**G-12507
JUNE 2012**

SUBJECT: SAFETY RECALL
Step mounting brackets on certain LoneStar® and ProStar® models built 03/24/2011 thru 11/22/2011 with feature code 08VTS, 08JAU, or 08JAW battery box-mounted step

Figure 1 Battery Box Step

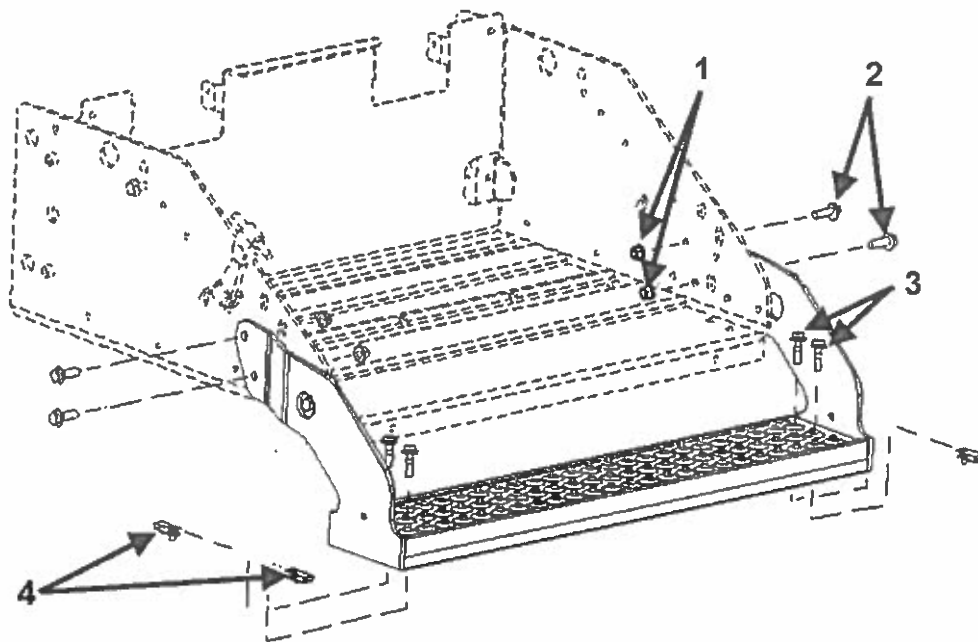
The mounting brackets used to install the battery box lower step were assembled with two welds instead of three welds and may allow the step mount to break off from the bracket. A failure of the step mounting bracket may cause the step to unexpectedly break off which can result in property damage, personal injury, or death.

2. Remove the step from the mounting brackets and save the bolts for reuse (see Figure 1). If the step is missing, proceed to step four.
3. Remove the speed “U” nuts from the mounting brackets and save the nuts for reuse.
4. Remove the right and left side mounting brackets from the battery box and save the mounting hardware for reuse.
5. Install the new mounting brackets to the battery box.
6. Install the speed “U” nuts onto the mounting brackets.
7. Install the step.
8. Remove the wheel blocks.
